**From:** Zoran Sarin <Zoran.Sarin@campbelltown.nsw.gov.au>  
**Sent:** Thursday, 8 June 2023 5:21 PM  
**To:** Gary Hinder  
**Cc:** Adrian Hohenzollern; Catherine Van Laeren; Jane Grose  
**Subject:** RE: Draft Gilead Stage 2 Instrument and maps for consultation.

### **Greater Macarthur Growth Area Gilead (Part) Precinct Plan Land Zoning Map – Sheet LZN\_007**

Greater Macarthur Growth Area  
Gilead (Part) Precinct Plan  
Land Zoning Map - Sheet LZN\_007

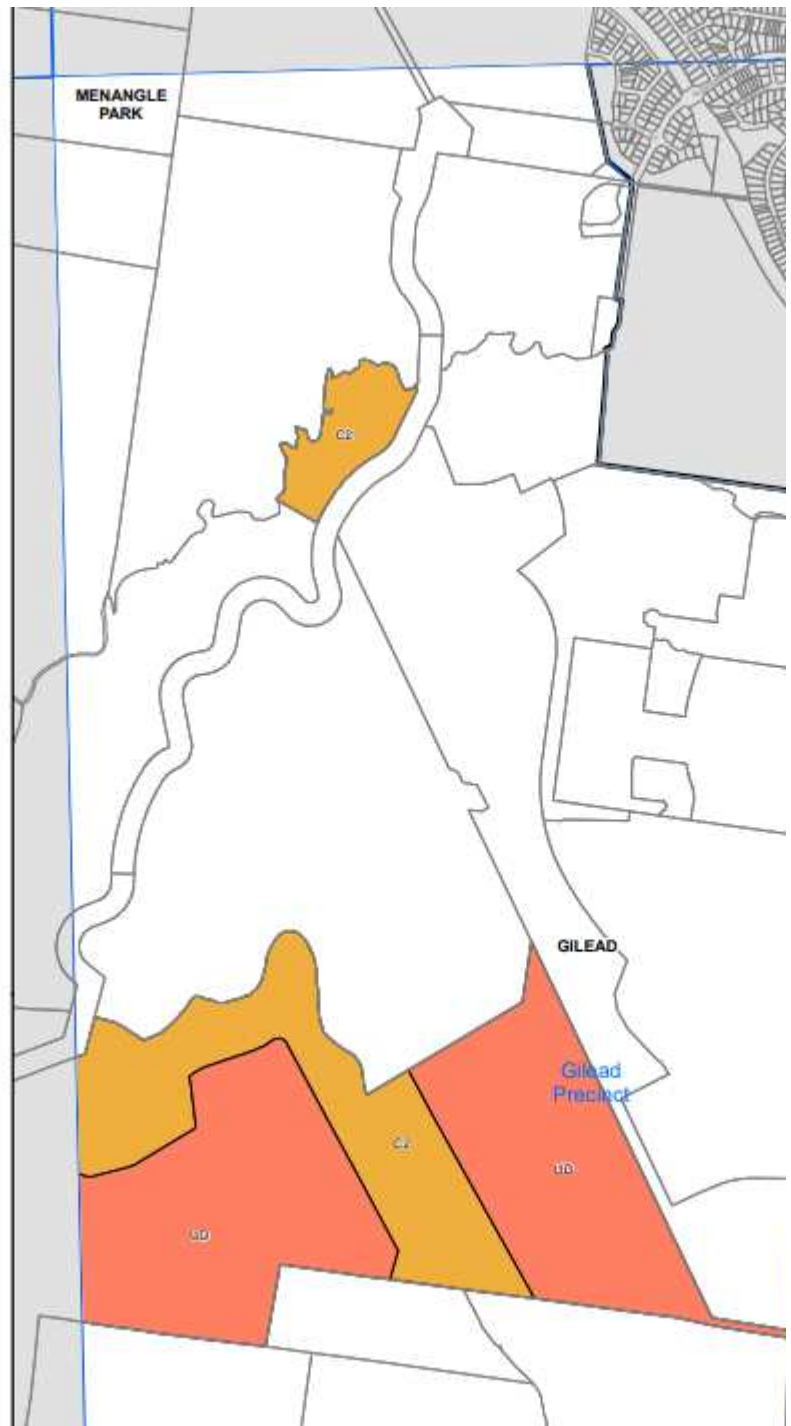
The following extract of Sheet LZN\_007 map includes SP2 zoning in the key without any SP2 zoned land:

Delete the SP2 from the key of Sheet LZN\_007 as it does not apply.
